3.2 Elevation Comparison Soap Street
Block B + C

Approved Material Key -
NMA Reference: 128851/
MMC/2020

4.0 Plan Comparisons

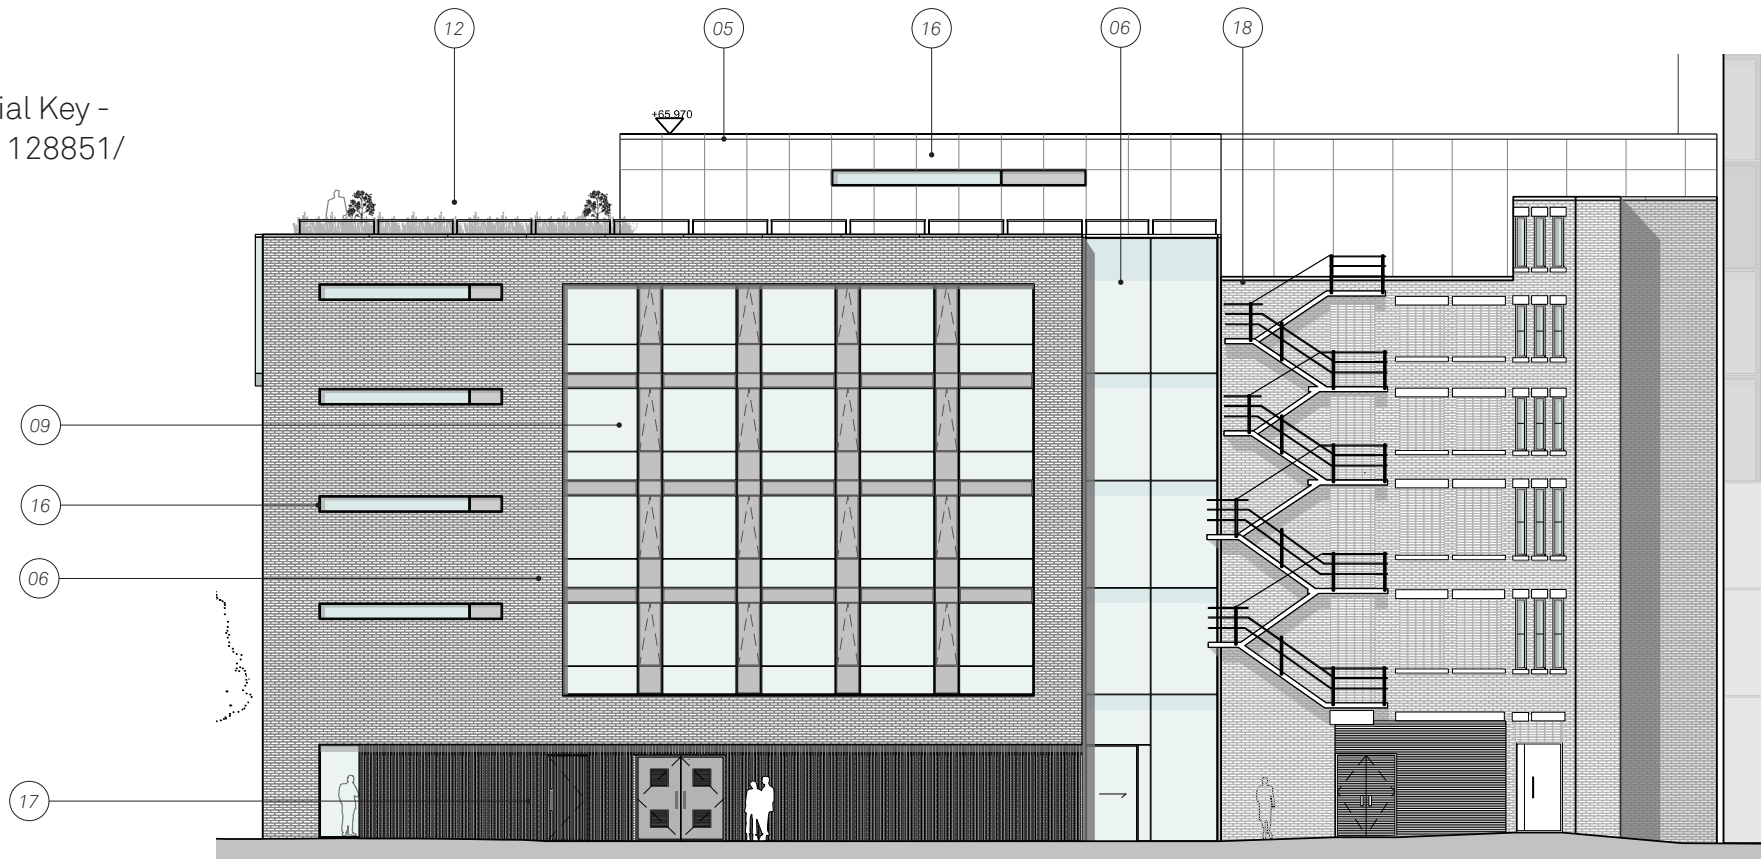
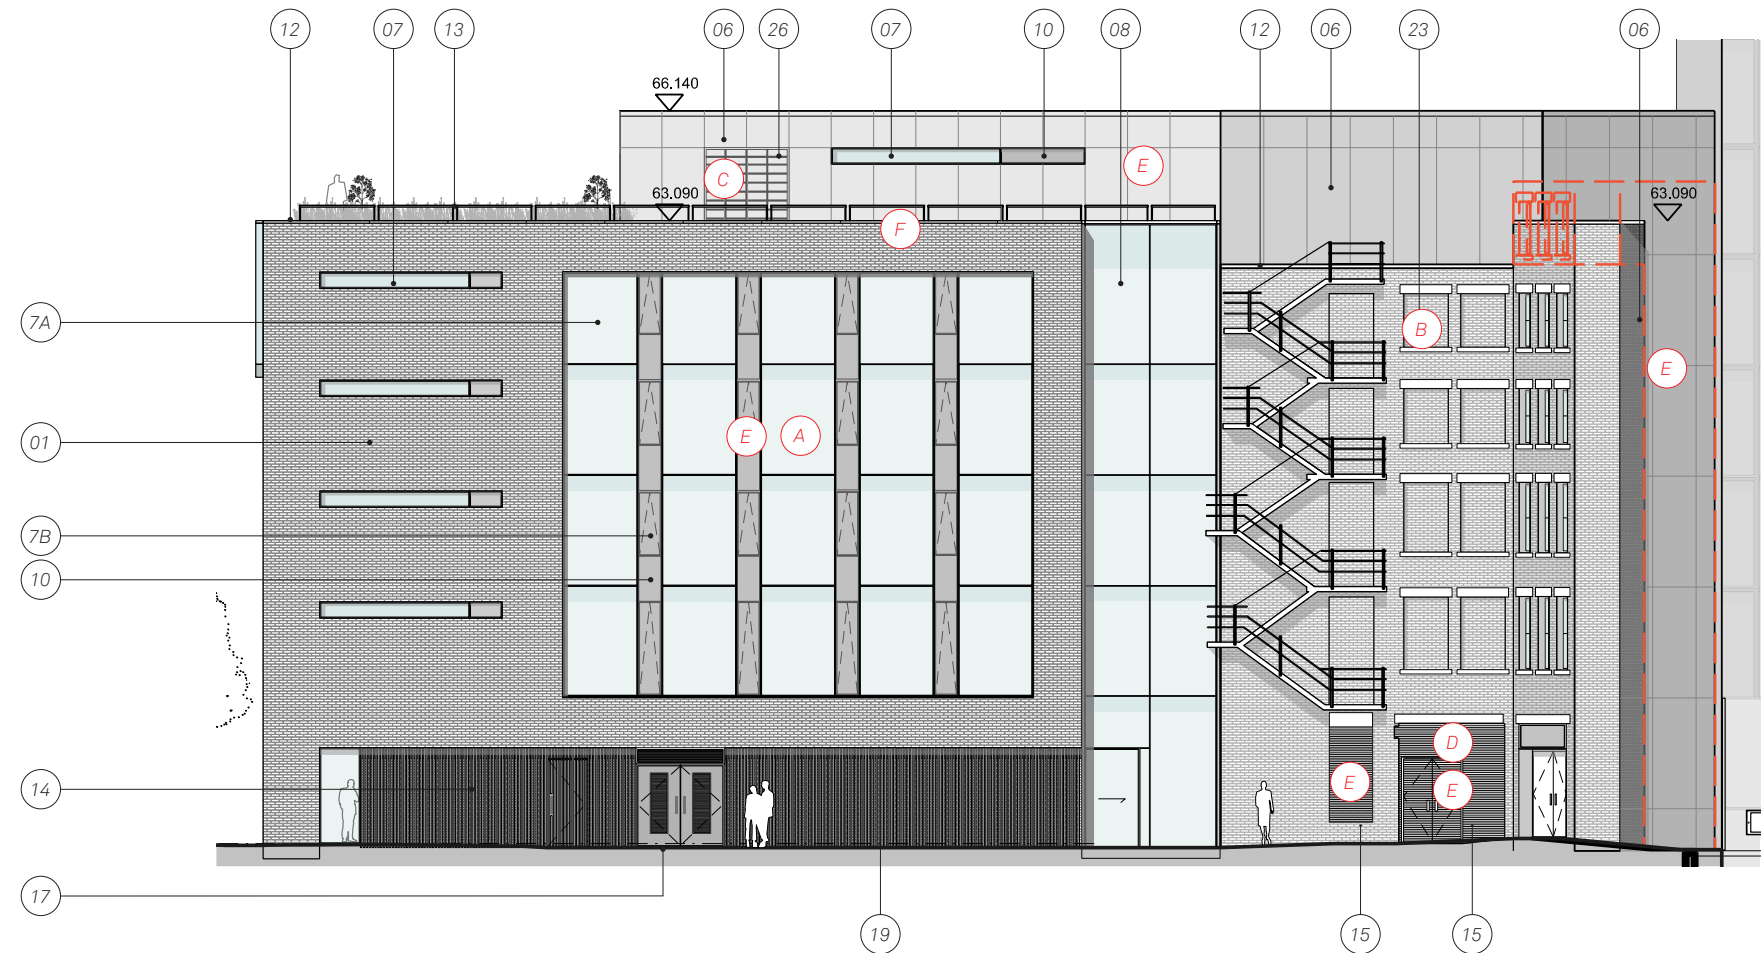
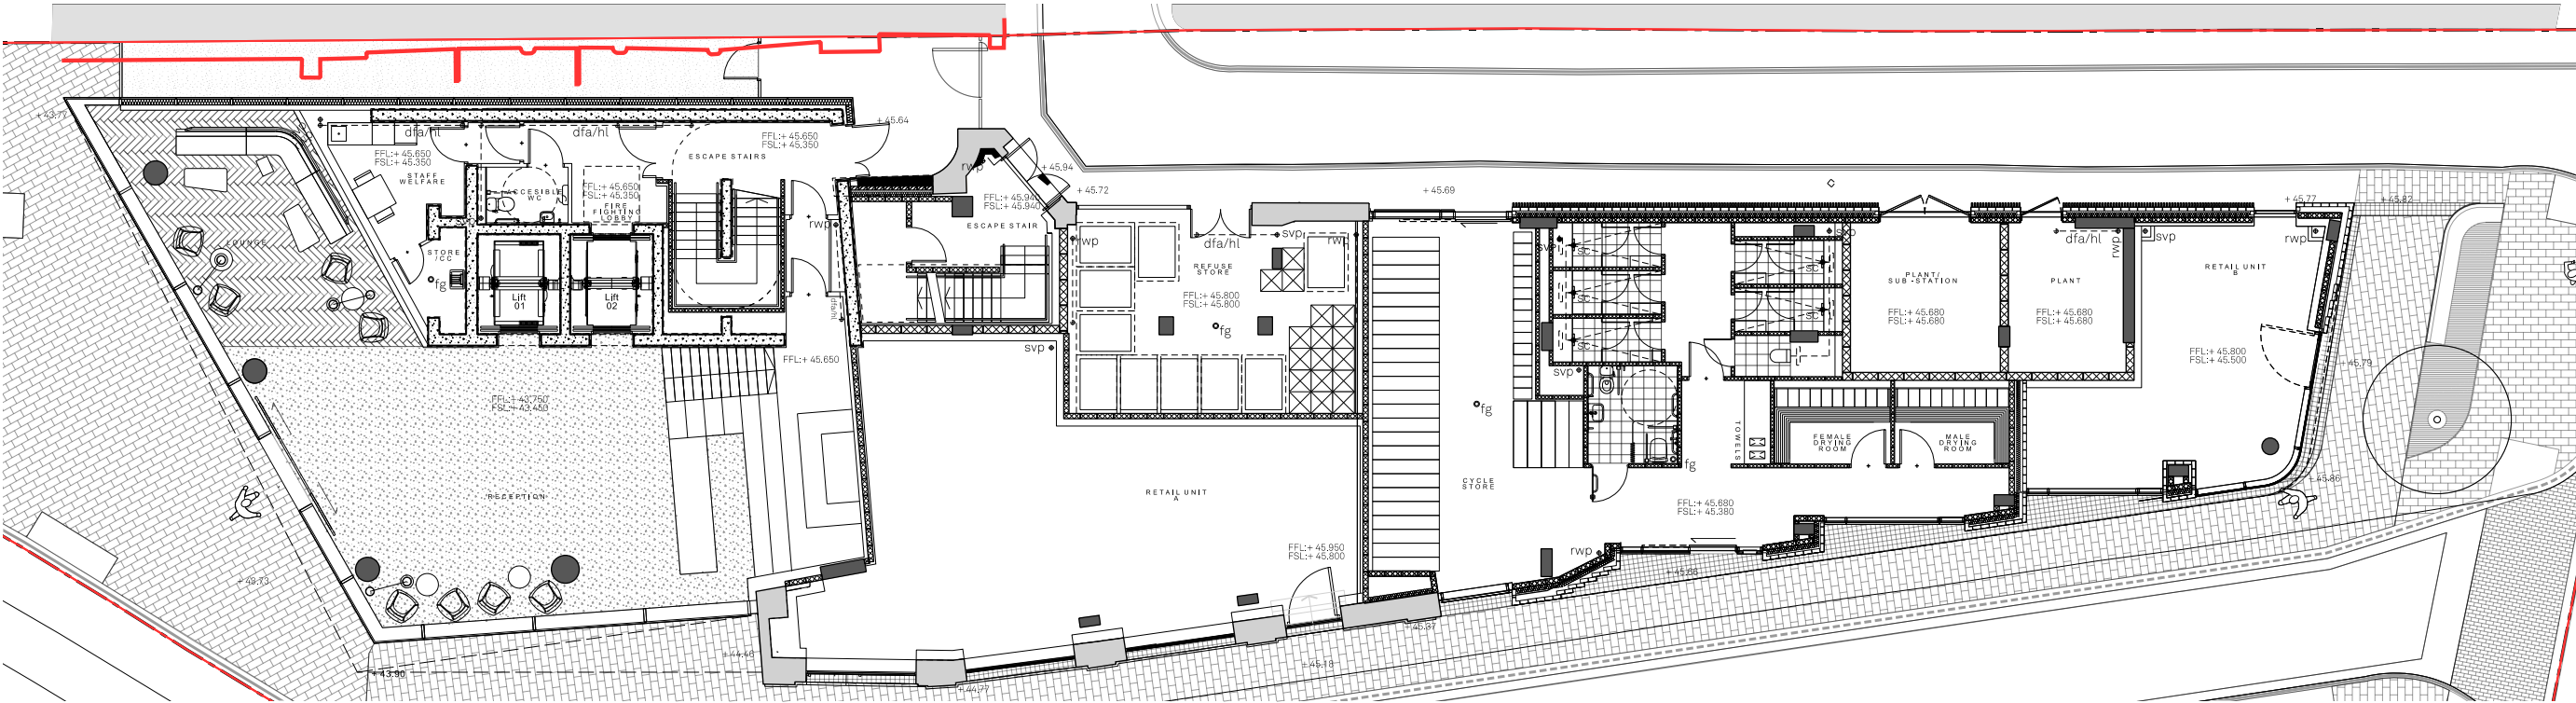
Summary of changes proposed

- . refined and simplified composition to glazing
- . minor brickwork amendments
- . existing brickwork wall to be Metal cladding to match level 05 metal cladding

Planning Material change Key

- A - The horizontal metal infill panels were removed to de-clutter the elevation and maintain the rhythm of the Back Turner St facade with a stronger verticality
- B - The brick infill panels have been revised to a brick to match and in the same stretcher bond as the existing
- C - Metal trellis added to allow some external planting as part Breeam request
- D - The extent of the louvres have been revised to suit the existing structural openings
- E - Metal cladding to be Bronze Colour. To be agreed VIA sample. Please refer to next page Section 3.2 for more info.
- F - Pre-cast stone coping. To be agreed VIA sample

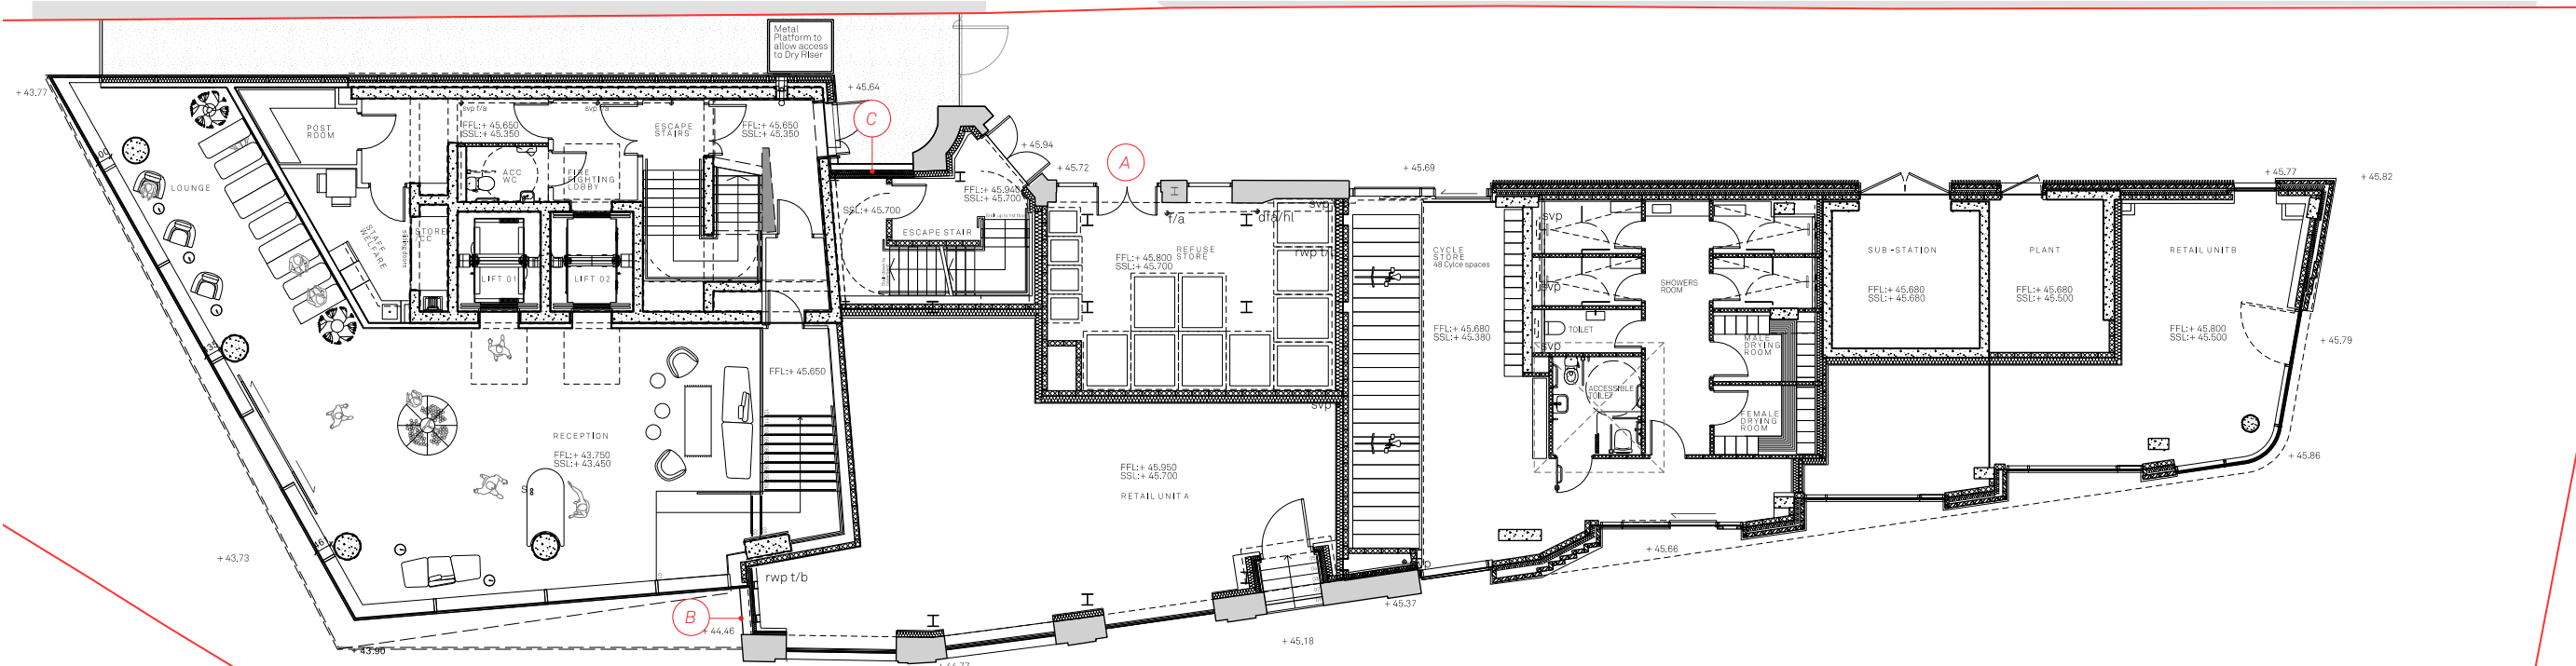
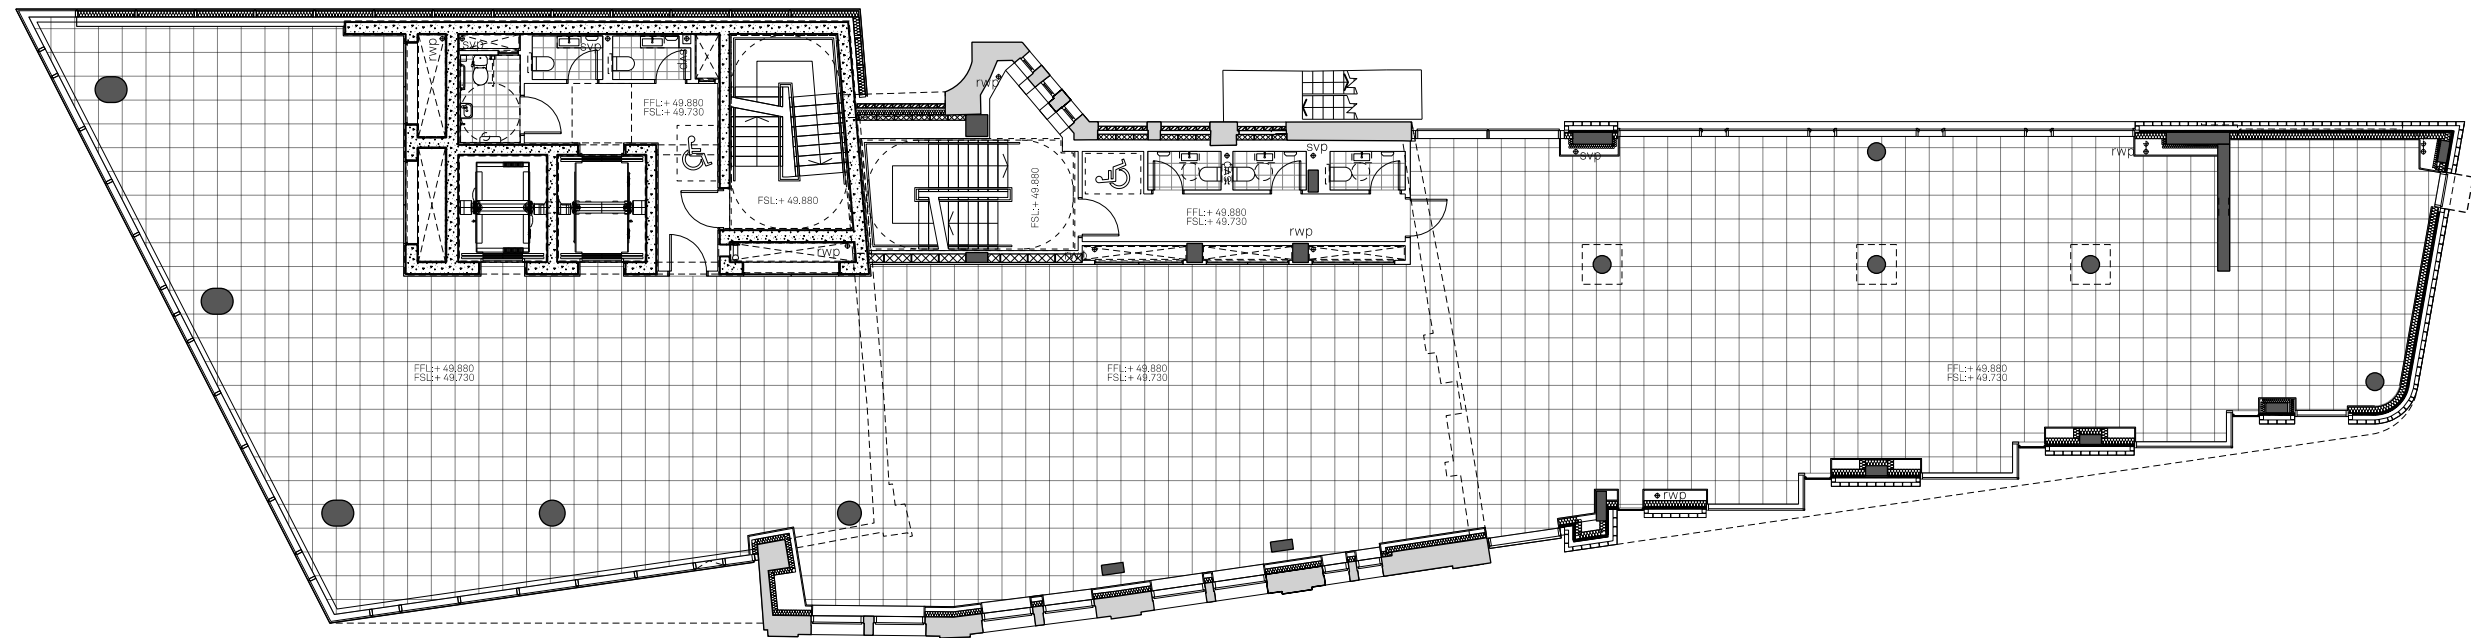
Planning Material change Key

- A - Louvred screen / door to refuse area amended. See Soap St elevation
- B - Existing brick replaced with Bronze PPC panel. Module size TBC
- C - Existing brick replaced with Bronze PPC panel. Module size TBC
